New electrical interfaces and a new cooling system for liquid-cooled generator for SAF TRAKr

As part of continuous product optimizations, SAF-HOLLAND will switch the liquid-cooled generator **SAF EM640023-SPL** of the SAF TRAKr to new electrical interfaces starting on 1st of November 2026.

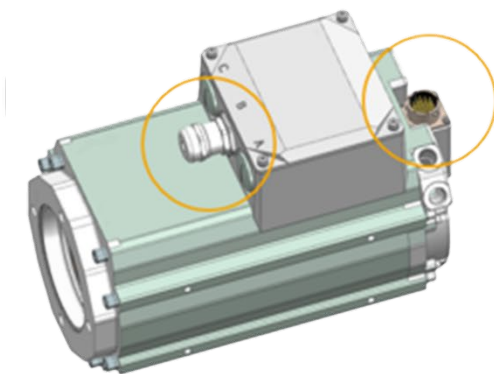
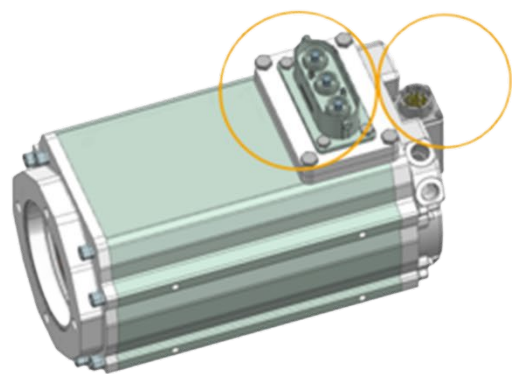
Previous version:
SAF 91 422 6524 00

New version:
SAF 91 422 6524 02

The advantages of the new electrical interfaces are:

- Easier, faster and safer assembly of the High Voltage (HV) connection
- Safer assembly of the Signal (LV) connection
- New electrical interfaces are identical to the electrical interfaces of the upcoming air-cooled generator for the SAF TRAKr

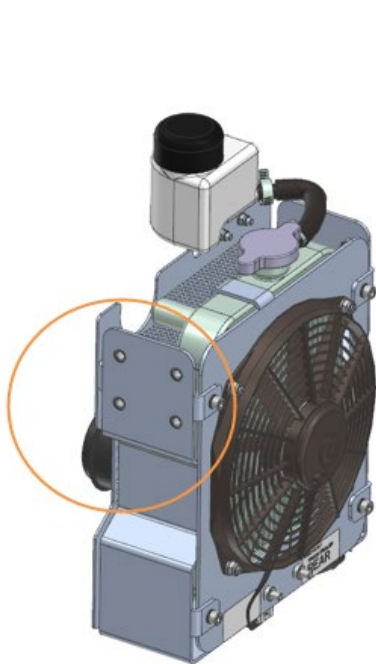
High Voltage (HV) wiring (8.0 m):
SAF 04 424 2048 00

Signal (LV) wiring (8.0 m):
SAF 04 424 2049 00

With the introduction of the new electrical interfaces for the liquid-cooled generator, SAF-HOLLAND will extend the delivery scope of every SAF TRAKr with the High voltage (HV) and Signal (LV) wirings for the generator. The length of the wirings is 8.0 meters.

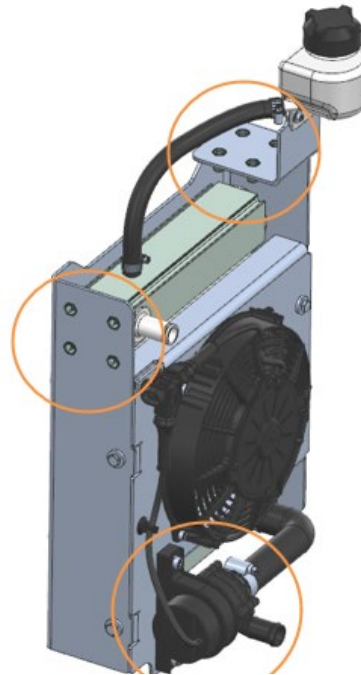
In addition, SAF-HOLLAND is switching to a new cooling system for the liquid-cooled generator, featuring an optimized pump arrangement on the rear of the cooling system as well as optimized connection points.

Previous version:
SAF 03 422 5090 01

New version:
SAF 03 422 1615 00
